The MUNICIPAL INFRASTRUCTURE Group Ltd.

ROUNDEL HOMES INC. (PH-2)

LOT No. 64

CURRENT DRIVE

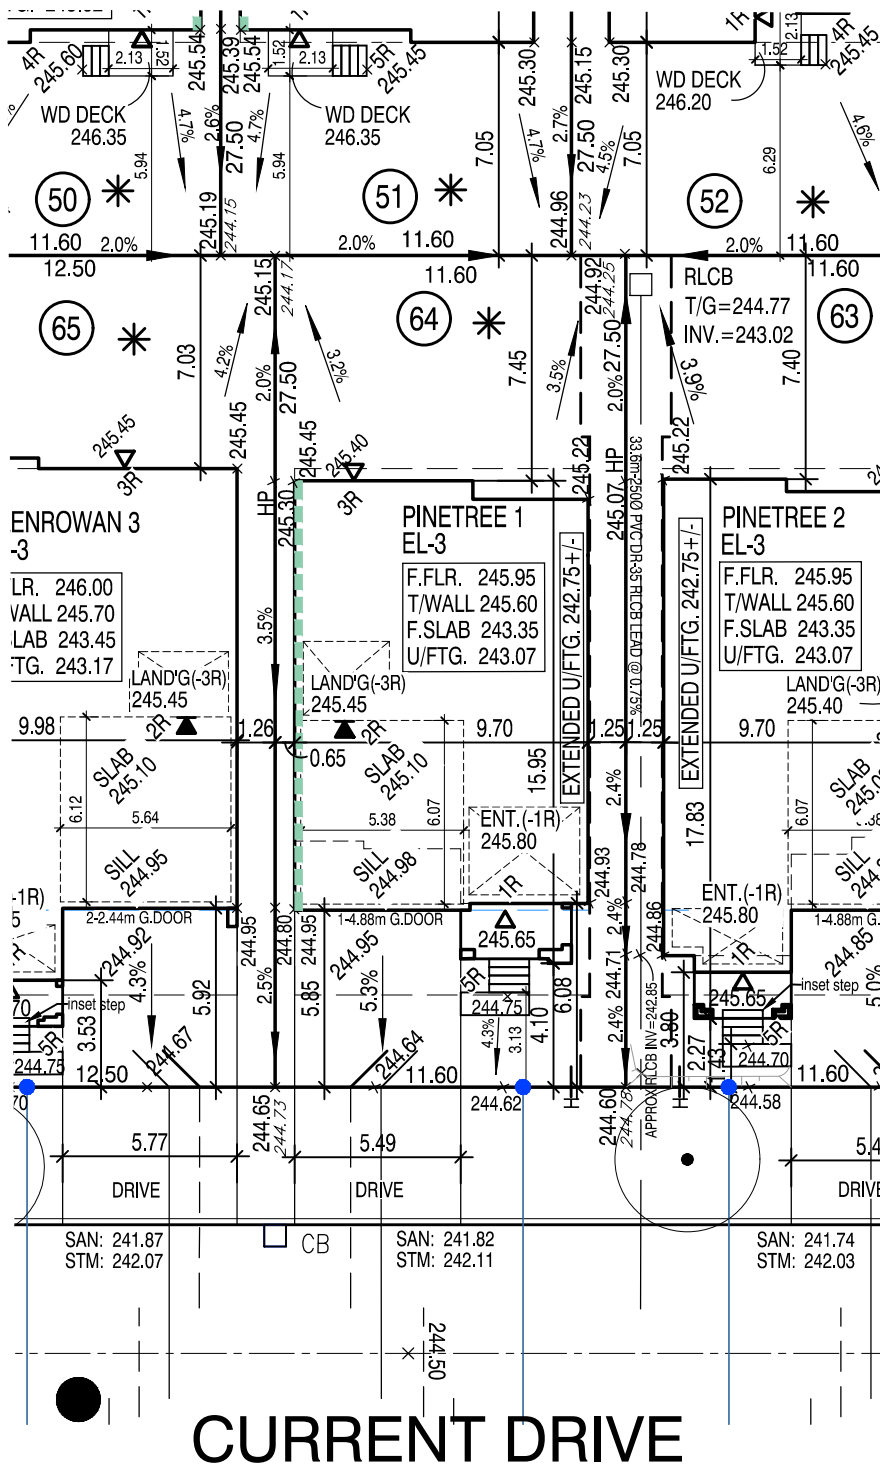
No unprotected openings permitted within 1.2 metres of the lot line as per 9.10.14 of the Ontario Building Code.

45 MINUTE RATED WALL WITH SIDE YARD < 1.2m
